October 9, 2007

In Reply Refer To:  
HSSD/LS-65

This letter is a reply to your mail correspondence of September 2, 2007, requesting the Federal Highway Administration (FHWA) acceptance of your company's HAPCO Lighting Poles Embed Breakaway Joints for use on the National Highway System (NHS) under the provisions of National Cooperative Highway Research Program (NCHRP) Report 350 "Recommended Procedures for the Safety Performance Evaluation of Highway Features." Accompanying your letter was a report on testing of your system conducted by the Texas Transportation Institute (TTI) and test videos.

Figure C1. HAPCO A89961 lighting pole.

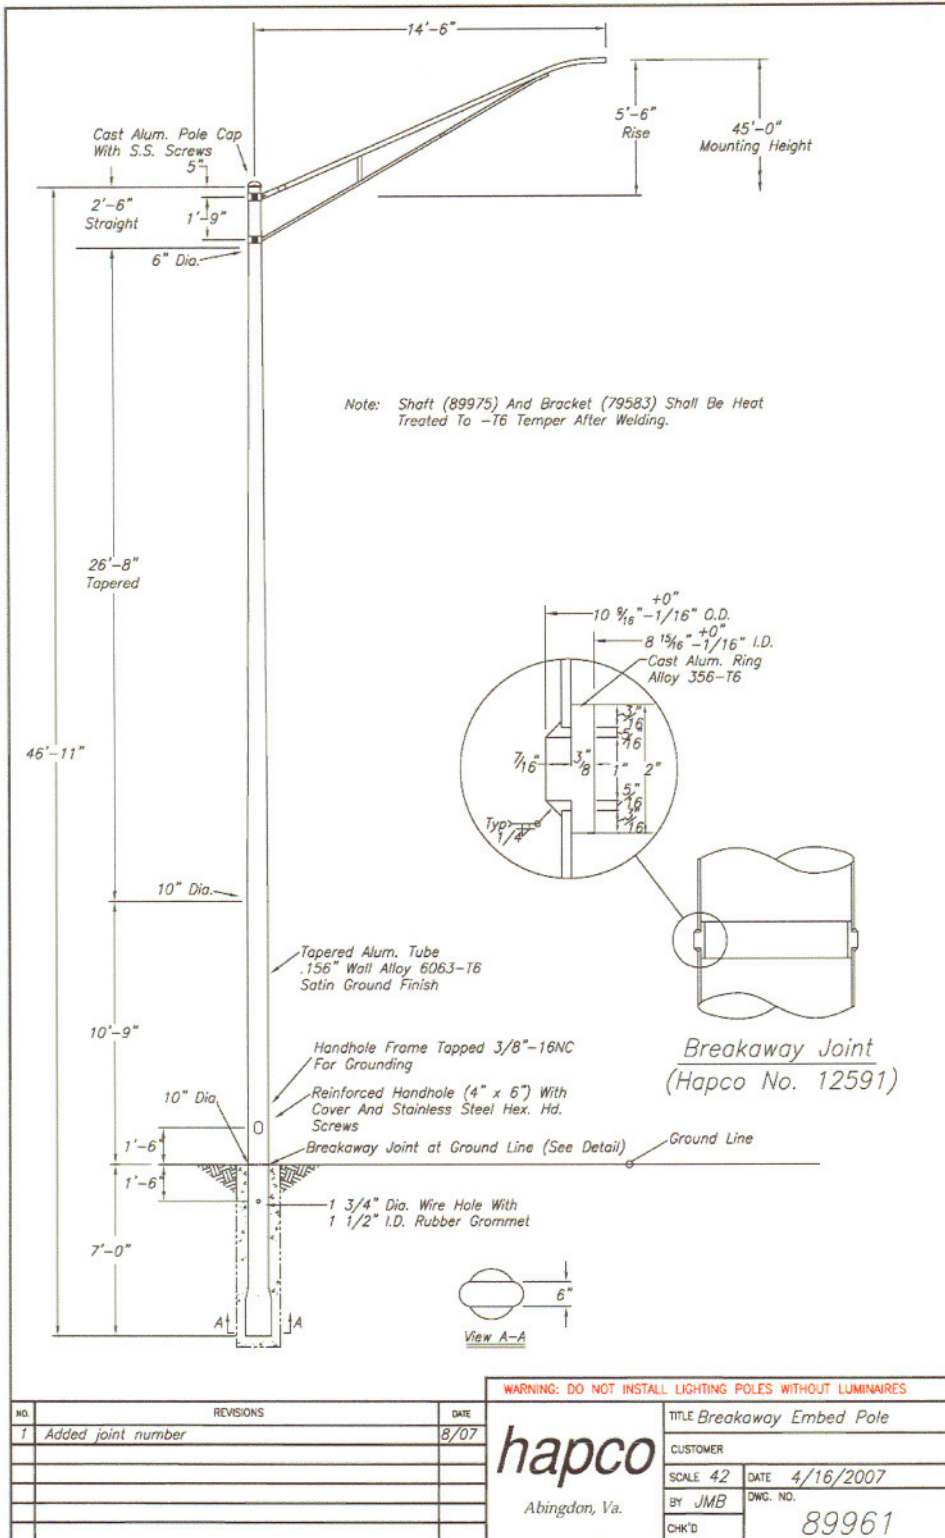
- 1) *HAPCO Breakaway Joint 12591* is at the ground line and consists of a cast aluminum ring (Alloy 356-T6) placed inside the foundation tube and tapered support tube. This ring was welded to each mating surface using groove and fillet welds. The thickness of the ring varied from 3/8 inches to 13/16 inches. A drawing is enclosed for reference. The joint was tested using *HAPCO A89961 Lighting Pole*. The lighting pole including foundation tube is a 46 foot - 11 inches long tapered aluminum tube (Alloy 6063-T6) with a 10 inch diameter at ground level, 6 inch diameter at the top, and wall thickness of 0.156 inches. The total height with light fixture is 45 feet. The weight of the pole with base is 211 pounds, the luminaire arm is 42.5 pounds, and the light fixture is 38 pounds, totaling a weight of 291.5 pounds. The pole was installed to a depth of 7 feet in crushed limestone.

- 1.) The test of *HAPCO Breakaway Joint 12591* yielded an occupant impact velocity of 4.1 m/s, ridedown acceleration -0.6 g's, and a maximum change in velocity of 4.5 m/s.
- 2.) The test of *HAPCO Breakaway Joint 12592* yielded an occupant impact velocity of 2.5 m/s, ridedown acceleration -0.6 g's, and a maximum change in velocity of 2.2 m/s.
- 3.) The test of *HAPCO Breakaway Joint 12593* yielded an occupant impact velocity of 2.9 m/s, ridedown acceleration -0.7 g's, and a maximum change in velocity of 3 m/s.

In summary, we agree that *HAPCO 12591*, *HAPCO 12592* and *HAPCO 12593* breakaway joints as described above, meet the appropriate evaluation criteria for NCHRP 350 Test Level 3 devices and may be used at all appropriate locations on the NHS when selected by the contracting authority, subject to the provisions of Title 23, Code of Federal Regulations, Section 635.411 as they pertain to proprietary products. This acceptance is limited to round aluminum poles (alloy 6063-T6 heat treated after welding) with luminaire mounting heights up to 45 ft. with shafts of up to .156 inches wall thickness with diameters of up to 10 inches and embedment lengths not less than 7 feet. The condition of each lighting pole is classified as not being repairable due to the damage from impacts. All electrical wiring connectors must be breakaway for the poles that will be wired in the ground for power.

Figure C2. HAPCO B89962 lighting pole.

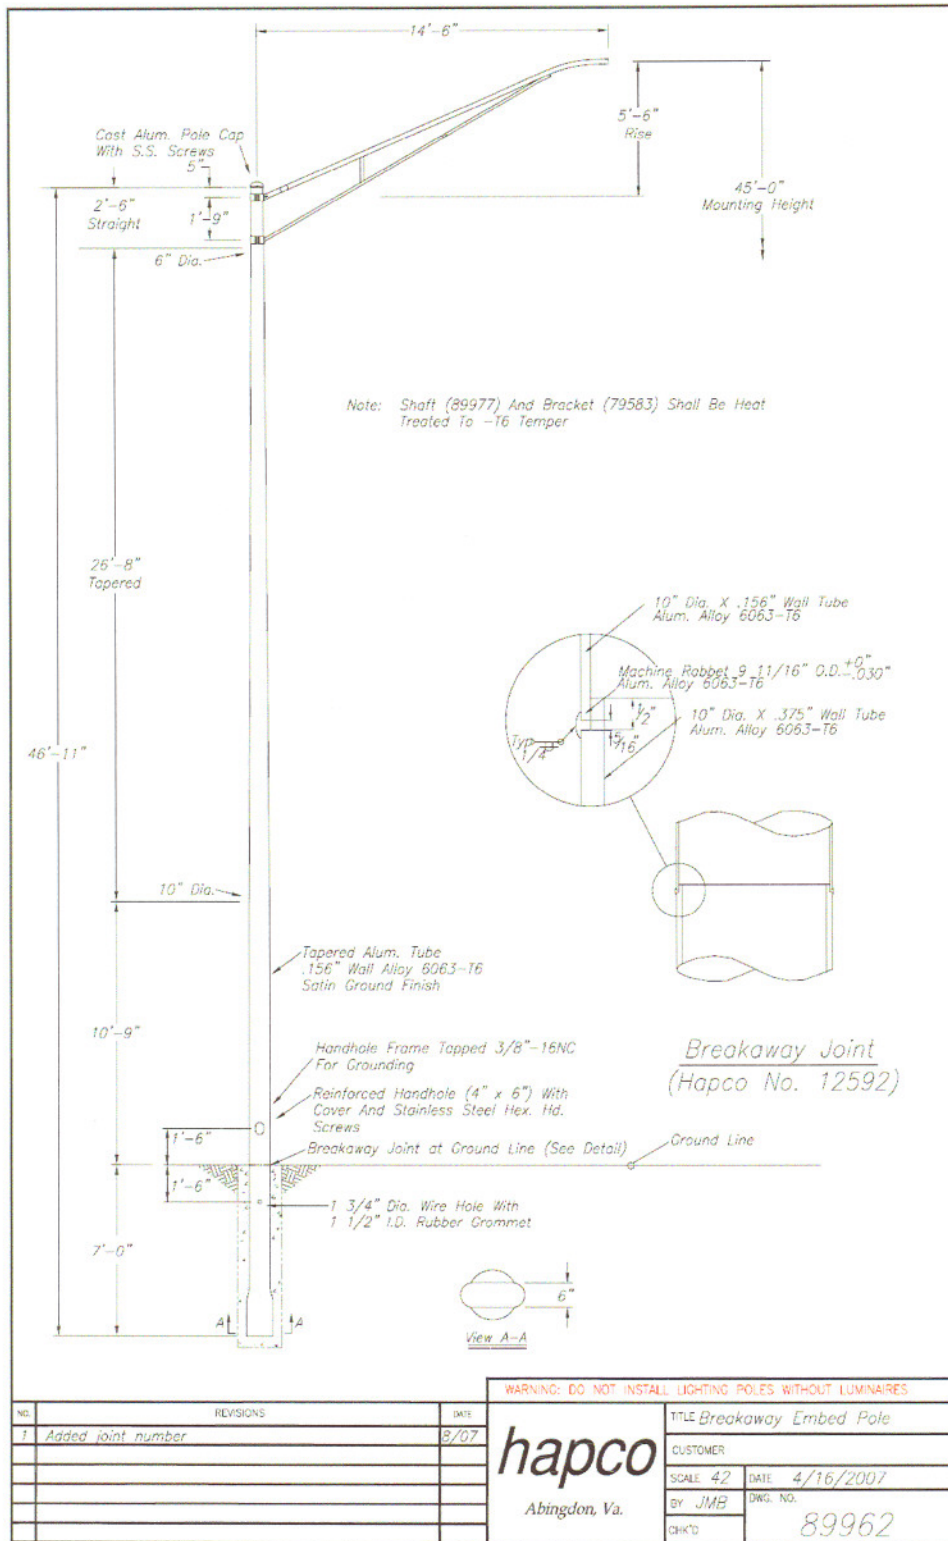
- 2) *HAPCO Breakaway Joint 12592* is at the ground line and consists of the 10 inch diameter tapered tube fitting onto a 9 11/16 inch outside diameter machine rabbet joint in the 10 inch diameter by 3/8 inch thick foundation tube. A drawing is enclosed for reference. The joint was tested using *HAPCO B89962 Lighting Pole*. The lighting pole including foundation tube is a 46 foot - 11 inches long tapered aluminum tube (Alloy 6063-T6) with a 10 inch diameter at ground level and a 6 inch diameter at the top. The total height with light fixture is 45 feet. The weight of the pole with base is 263 pounds, the luminaire arm is 42.5 pounds, and the light fixture is 38 pounds, totaling a weight of 343.5 pounds. The pole was installed to a depth of 7 feet in crushed limestone.

Figure C3. HAPCO B89963 lighting pole.

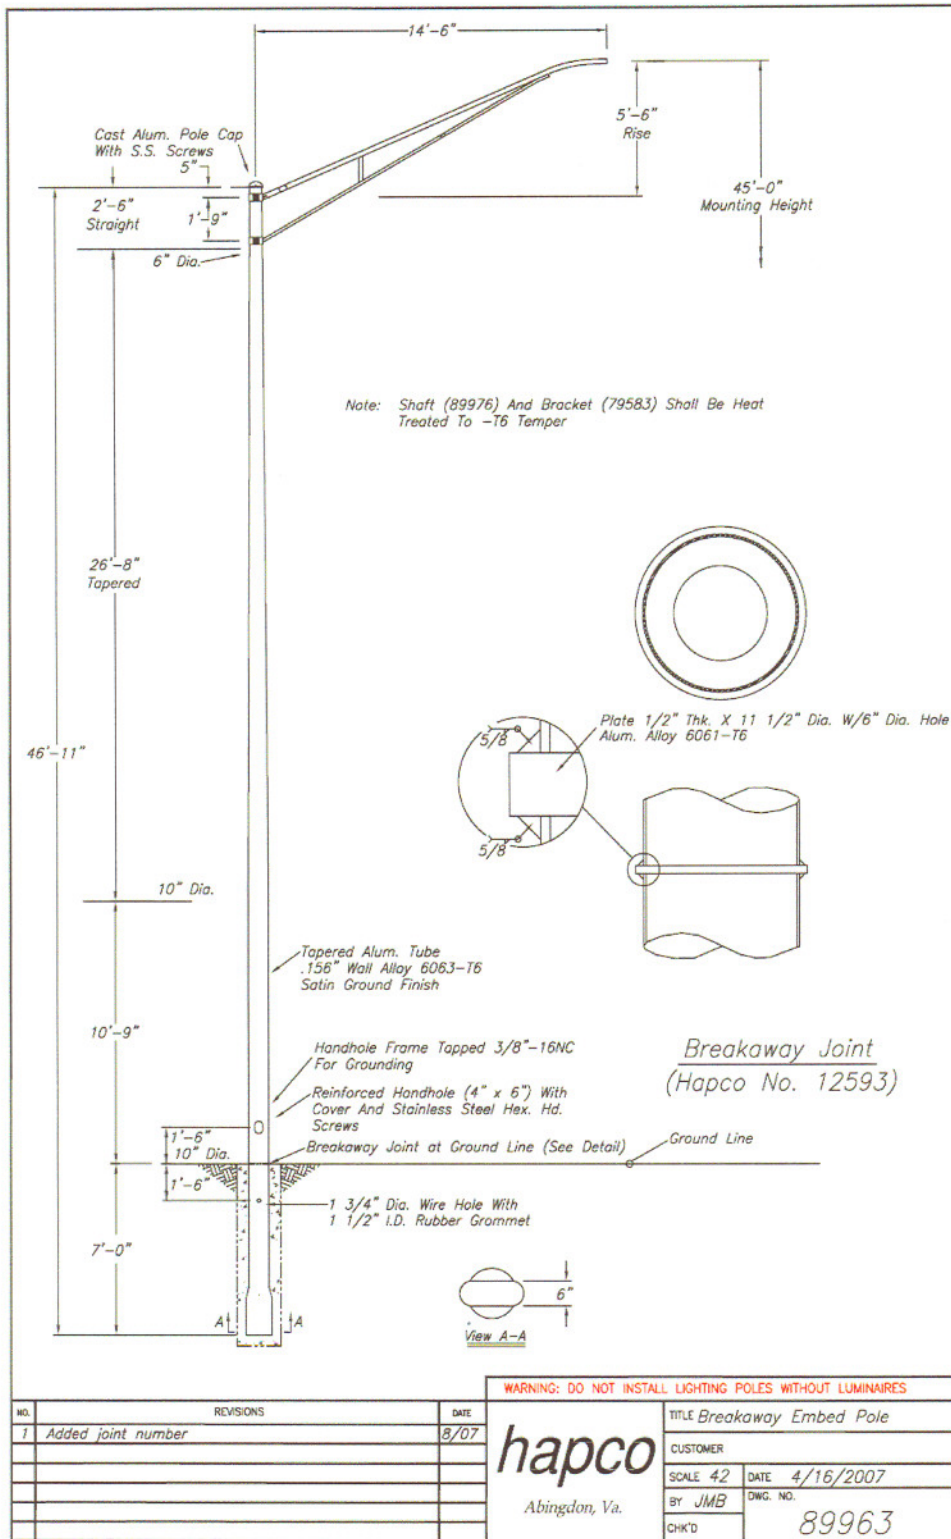
- 3) *HAPCO Breakaway Joint 12593* is at the ground line and consists of the 1/2 inch thick plate welded to the bottom of the tapered support tube. The plate is also welded to the top of the foundation tube. Fillet welds (5/8 inch) are used to weld the plate to the support tube and the foundation tube. A drawing is enclosed for reference. The joint was tested using *HAPCO B89963 Lighting Pole*. The lighting pole including foundation tube is a 46 foot - 11 inches long tapered aluminum tube (Alloy 6063-T6) with a 10 inch diameter at ground level and a 6 inch diameter at the top. The total height with light fixture is 45 feet. The weight of the pole with base is 211 pounds, the luminaire arm is 42.5 pounds, and the light fixture is 38 pounds, totaling a weight of 291.5 pounds. The pole was installed to a depth of 7 feet in crushed limestone.
